# **Service Information**

Category <b>S</b>	Repair Guidance		Ref. No. R048/16A	Page 1 of 2
Coverage  ☐ Distributor only ■ Please inform your dealers			Date Issued May 30, 2016	
Please convey this information to your ☐ Director ☐ General Manager ☐ Warranty Dept. ☐ Parts Dept. ☐ Training Dept. ☐ Field Rep.		9	Date Revised June 7, 2016	
Applicable Model		Applicable Countries or Specifications		
MX-5 (ND) without INNER CLOTH		Worldwide

## **Subject: Rubbing/Contact Marks on CONVERTIBLE TOP (Top Fabric)**

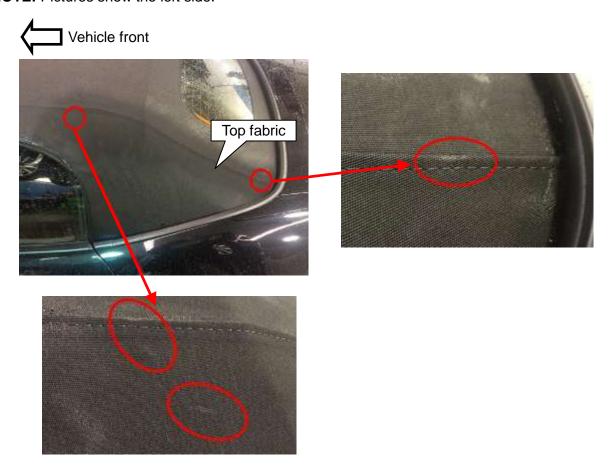
Some vehicles may exhibit rubbing/contact marks on the top fabric of convertible top around the area shown in figure below. Marks may occur on the right and/or left side(s).

NOTE: Pictures show the left side.

While the vehicle is running with the convertible top opened, the top fabric, being folded and piled up, receives vibration and the stitching line (hard) touches top fabric causing rubbing/contact marks.

The link stopper of convertible top has been changed to adjust the opening angle of the convertible top, thereby decreasing the contact pressure applied to the top fabric when folded and piled up.

When you receive a customer complaint on this concern, replace the convertible top assembly with the modified one according to the procedure in the workshop manual "CONVERTIBLE TOP REMOVAL/INSTALLATION".
